Amendments to the Drawings

REMARKS/ARGUMENTS

FIGURE 2C

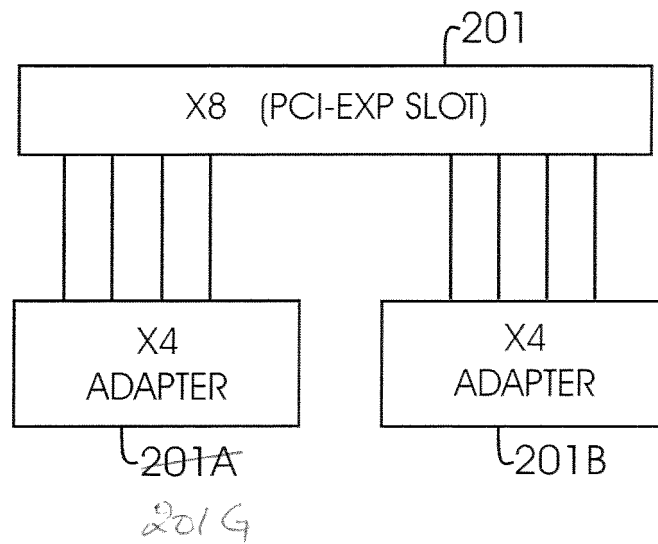
The attached sheet of drawings includes changes to Figs. 2C. In Fig. 2C, reference number
“201A” has been replaced by “201G”. This amendment is in conformity with the description of
5 the drawings in the specification. No new matter has been added.
Acceptance of the amended drawing (Fig. 2C) is respectfully requested.

In amended Figure 2C, reference number "201A" has been replaced by "201G" to bring the drawings in conformity with the specification. A copy of annotated sheet along with re-
15 placement sheet is enclosed.
